U.S. Department  
of Transportation  
**Federal Highway  
Administration**

In Reply Refer To:  
HSSD/B-159

Thank you for your letter of December 18, 2006, requesting the Federal Highway Administration's (FHWA) acceptance of the **BarrierGuard™ 800 (BG 800) – Gate of Highway Care, Ltd.** (a UK company) and Laura Metaal Eyselshoven, BV, for use on the National Highway System (NHS) under the provisions of National Cooperative Highway Research Program (NCHRP) Report 350 "Recommended Procedures for the Safety Performance Evaluation of Highway Features". Accompanying your letter was a report on testing of your company's BarrierGuard™ 800 - Gate prepared by Safe Technologies Inc, test videos, drawings and previously prepared crash test reports providing additional information and background, including report on crash testing of regular BarrierGuard™ 800 system of October 2004.

Typical 6 meter BarrierGuard 800 Gate

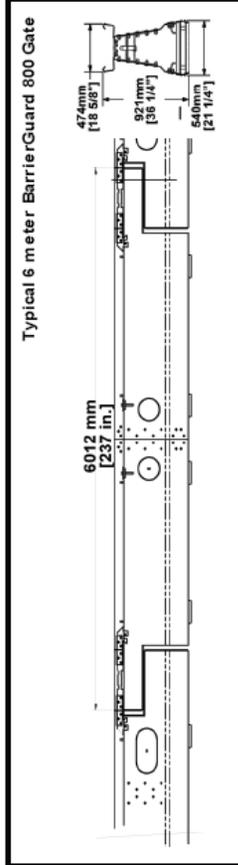
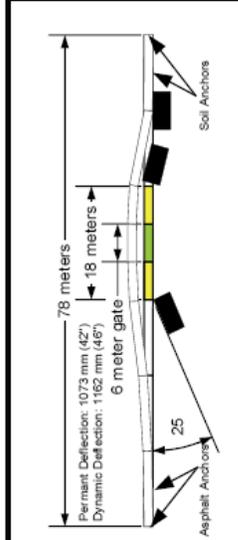
The full-scale NCHRP Report 350 Test 3-21 conducted on your company's BarrierGuard™ 800 - Gate involved a 2000P vehicle impacting the device at 97.9 km/h and 25.0 degree angle, at the point 4 meters (13 ft) upstream from the upstream hinge point of the gate. The vehicle was redirected along the length of the barrier with the exit angle essentially parallel to the downstream barrier.

The impacted section and the downstream sections of the barrier received minor to moderate damage. The gate section was dented in the impact area, but did not separate or tear. The upstream and downstream barrier end section anchors did not lift or significantly damage the asphalt. There was no debris expelled from the barrier. The maximum lateral dynamic deflection was 1162 mm (46") and the maximum permanent deflection of the test article was 1073 mm (42"). The gate remained functional after the test.

All occupant risk factors were within the limits specified in the NCHRP Report 350. The theoretical occupant impact velocity values in the longitudinal and lateral directions were 5.2 m/s and 4.9 m/s respectively and the theoretical occupant ridedown acceleration values in the longitudinal and lateral directions were 6.1 g and 7.5 g respectively. Summary of test results is provided in Enclosure 2.

In summary I agree that BarrierGuard™ 800 - Gate, as described above, meets the appropriate evaluation criteria for NCHRP 350 TL-3 longitudinal barriers and may be used at all appropriate locations on the NHS when selected by the contracting authority, subject to the provisions of Title 23, Code of Federal Regulations, Section 635.411 as they pertain to proprietary products. It can be used with regular application of BarrierGuard™ 800 or, when properly transitioned, with the Minimum Deflection System. This acceptance is based on the reported crash performance of the BarrierGuard™ 800 - Gate. Further, I am assuming that production models will be identical to the prototype test units.
